Product Change Notice

Issue Date: 27-November-2017

Assembly Related: Qualification of alternate contract manufacturer for all LPCC, QFN packages.

Type	MGA-13116	MGA-13216	MGA-13316
Current			
New

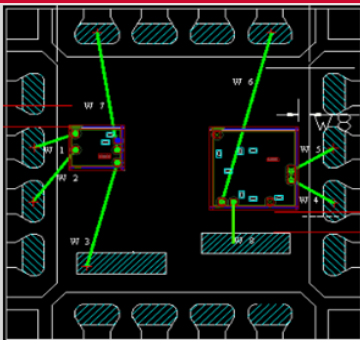
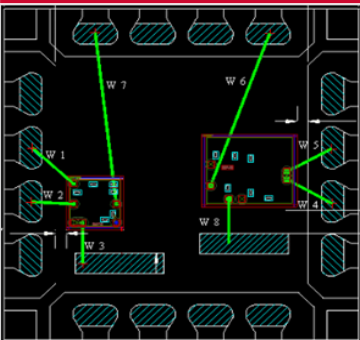
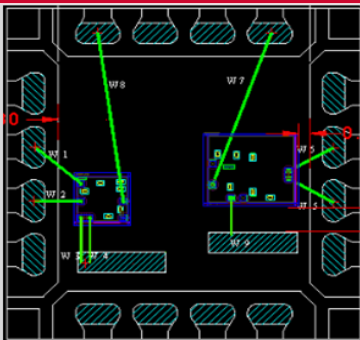
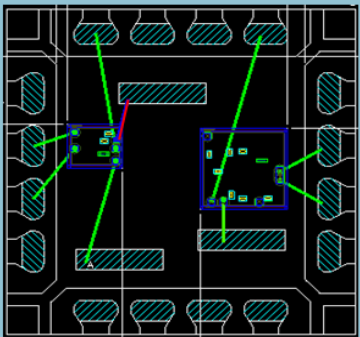
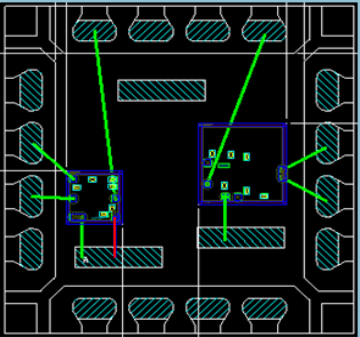
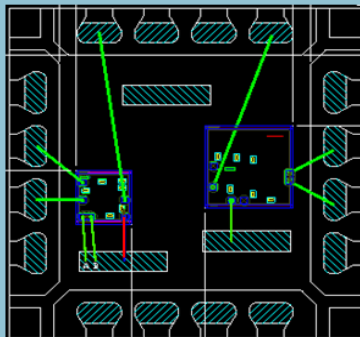
Wire bond Related: Add wire bonding.

Change Type 2: To stabilize the Idd1 parameter and for continuous product improvement.
